CITY OF ALBUQUERQUE

**RE: Lot 25 Block 6 Unit 18 SAD 228
6519 Pato Rd. NW
Volcano Cliffs Subdivision
Grading and Drainage Plan
Engineers Stamp Date; 9/19/19 (D10D003M25)
Pad Certification Date; 10/8/19
C.O. Certification Date; 6/3/2020**

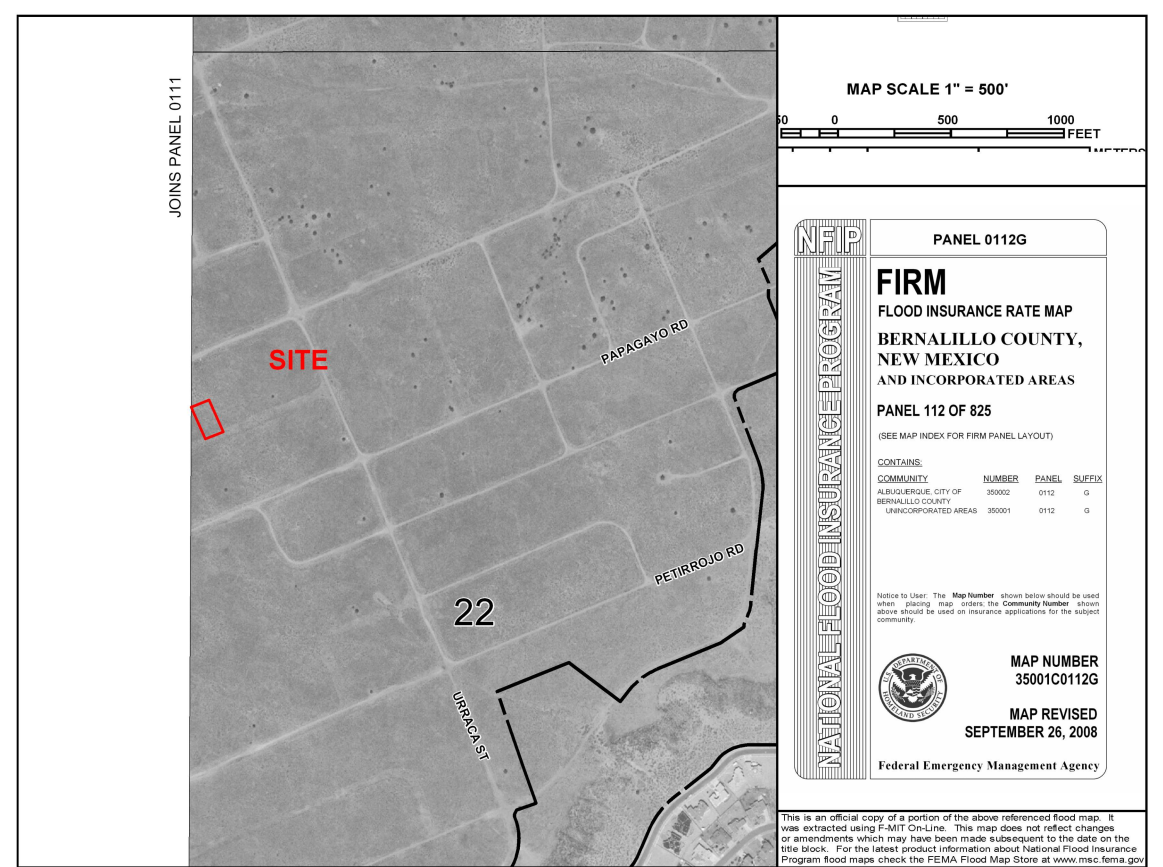
- Provide a new date for the changes to the plan.
- Provide the approved Pad Cert. language on the plan.
- Provide a statement that the plans are ready for CO.
